BCA ASSESSMENT REPORT

52&54 Brighton Street, Freshwater

Project Number: 1
Report Type: BCA
R: 1
Date: 7 July 2023

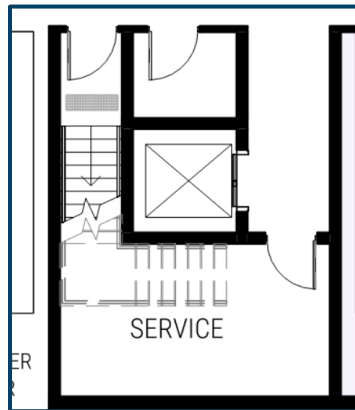
Egress from the carpark is required in sufficient numbers and location to ensure that no point on the floor is more than 20m from an exit, or a point of choice of two exits, in which case the distance to one of those exits is not more than 40m, as required by clause D2D5 of the BCA. On the ground floor, the distance to a single exit is permitted to be 30m. The exit travel distance from a point of choice is more than 20m and therefore is non-compliant, this will require a Fire Engineering Performance Solution.

In the residential portion of the building, the distance to an exit on the ground floor is permitted to be 20m. The distance to an exit on other floors is to be no more than 6m (12m for a sprinkler protected building) from any point on the floor to an exit, or a point of choice of 2 exits in which case the distance between those 2 exits is to exceed 45m. The travel distances and distances between alternative exits comply with the above.

Egress from the residential first floor is required in sufficient numbers to ensure that the front door of the SOU is no more than 6m from an exit. The travel distances from the First Floor SOUs are approximately 11m in lieu of the required 6m and is thus non-compliant, this will require a Fire Engineering Performance Solution.

The distance between alternative exits is required by Clause D2D6 of the BCA to be no closer than 9m and no further apart than 60m when measured through the point of choice. The travel distances between exits comply with the above requirements.

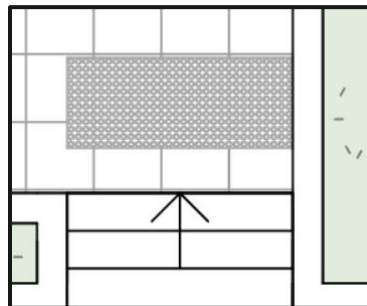
Barriers to all balconies and landings with a fall of more than 1m on the other side are required to be a minimum of 1m in height above the finished floor level as per BCA Clause D3D18.

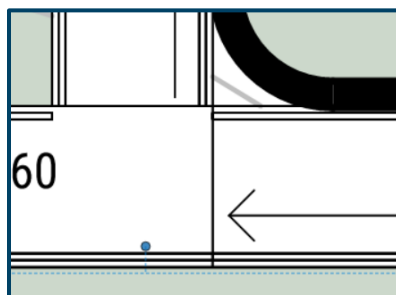
Handrails are required to all stairways and are to be of heights between 865mm to 1000mm above the stair nosing in accordance with BCA Clause D3D22. Handrails are required to the eastern stairway that leads to the egress ramp to be compliant with BCA Clause D3D22.

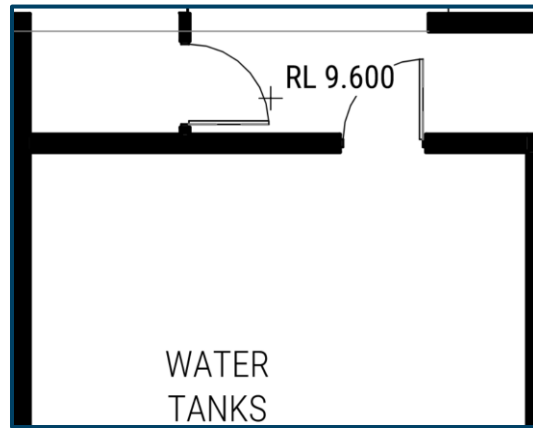
Handrails are required to be continuous, the 90 degree handrail turns at the eastern egress ramp have a break point and will required to be continuous to comply with the BCA Clause D3D22.
